Easy Settings, Highest Reliability, Simplified Maintenance

AA032 – Contactless Vacuum Drum

Equipment: SSC labellers (rollfed module), Evodeco

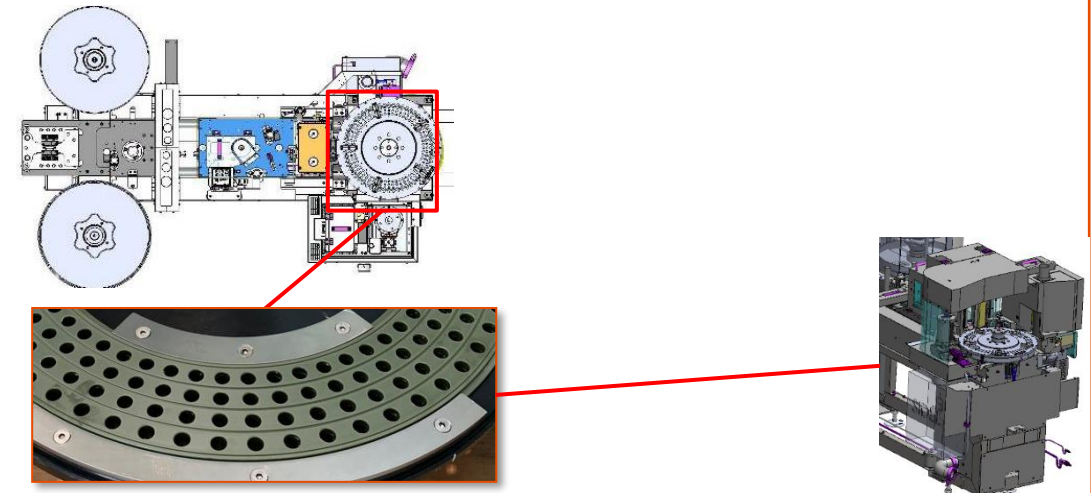
- The vacuum distributor in a fix position with calibrated spacer allows to avoid contact and friction; 0,1 mm of gap can ensure a controlled vacuum leakage and the drum motor torque decrease of 70%.
- Greasing interval decrease up to 70%, this will decrease the grease contamination on the vacuum channel and the cleaning interval on this area
- Avoid vacuum circuit contamination with grease.

- New vacuum distribution plate (green plastic plate) design
- The plate is completely compatible with previous one and grants:
 - *less contact surface area;*
 - *reduced friction and wear between parts;*
 - *no automatic grease hole obstruction;*
 - *greater uniformity in the grease distribution.*
